FINAL DRAINAGE REPORT FOR SADDLEHORN RANCH – FILING 4

> June 9, 2023 Project No. 25142.06

SF-23-006

DP 2.2 Swale (100-Year)(FR:0.59)

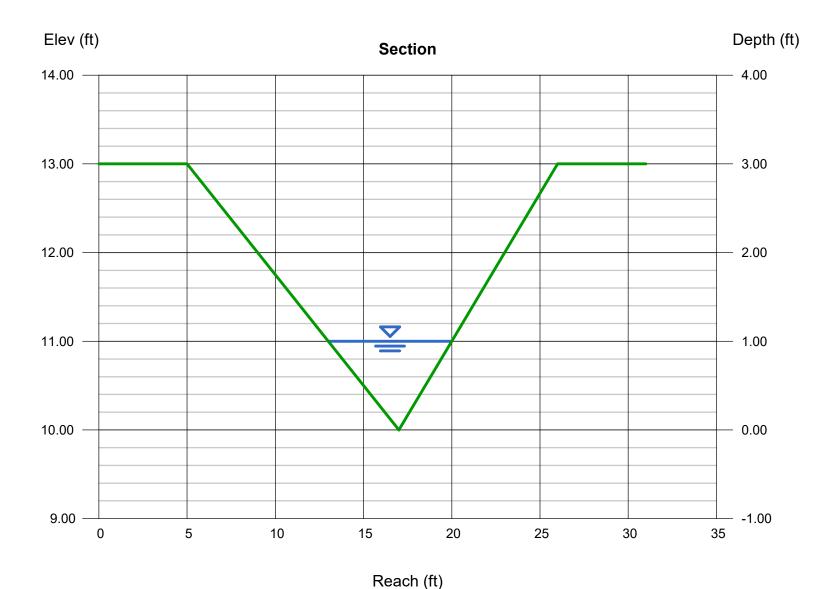
Triangular Highlighted Side Slopes (z:1) = 4.00, 3.00Depth (ft) = 1.79Total Depth (ft) = 3.00Q (cfs) = 50.00Area (sqft) = 11.21Invert Elev (ft) Velocity (ft/s) = 10.00= 4.46Slope (%) Wetted Perim (ft) = 13.04= 1.00N-Value = 0.030Crit Depth, Yc (ft) = 1.67Top Width (ft) = 12.53EGL (ft) **Calculations** = 2.10Compute by: Known Q Drainage plan shows a Known Q (cfs) = 50.00street slope of 1.74%. Please confirm swale slope and revise as needed. JR- 1% represents the max flow condition near

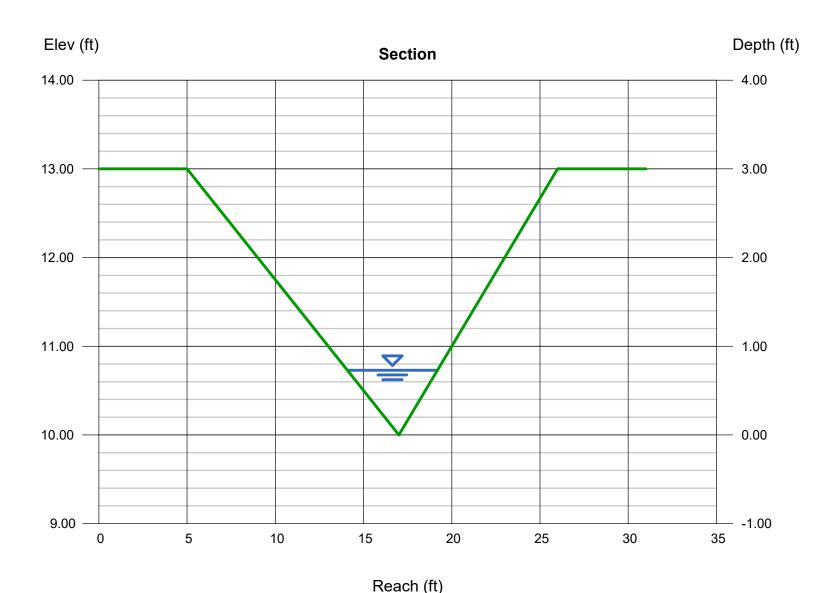
Drainage plan shows a street slope of 1.09%. Please confirm swale slope and revise as needed.
